## AP1000DCDFileNPEm Resource

**From:** Loza, Paul G. [lozapg@westinghouse.com]  
**Sent:** Friday, November 05, 2010 10:33 AM  
**To:** Buckberg, Perry  
**Cc:** Melton, Michael A; Schwab, E Keith; Salsi, Nathan J; Ritterbusch, Stanley E; Ziesing, Rolf F.  
**Subject:** RE: NRC Concern with AO/111% Overspeed Trip  
**Attachments:** RAI-SRP10 2-SBPA-02 R4 PGL draft (NA-Schwab update).docx; NRC 111 Keith110410.doc

## AP1000 TECHNICAL REPORT REVIEW

RAI Response Number: RAI-SRP10.2-SBPA-02

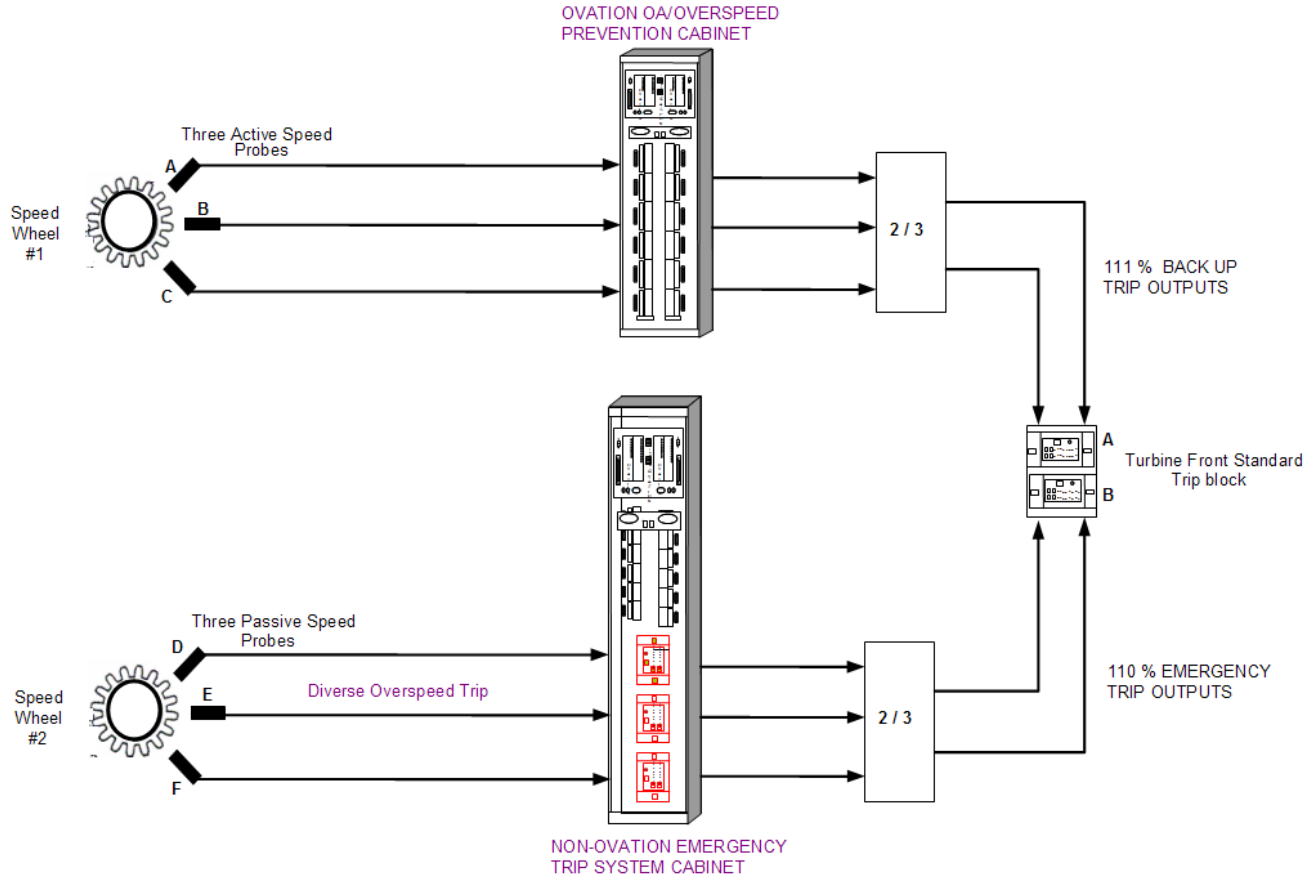
In addition, as a result of a conference call with the NRC on July 23, 2009, Westinghouse is proposing clarifications be made to Tier 2 DCD subsections 10.2.2.4.1, 10.2.2.4.5, and 10.2.2.5.3. Westinghouse stated in the conference call that both the 110% and 111% overspeed trip systems are not contained in a single controller and that one of the trips is contained in a non-Ovation controller. The commitment to separate these trips into separate, diverse controllers was made after DCD Revision 17 was issued in response to the staff's initial submittal of this RAI.

The DCD changes proposed below show and clarify that the 110% and 111% trip systems have diverse hardware and software/firmware to eliminate common cause failures (CCFs) from rendering the trip functions inoperable. A diagram is provided below to show the system configuration with a non-Ovation controller for the diverse 110% emergency trip system.
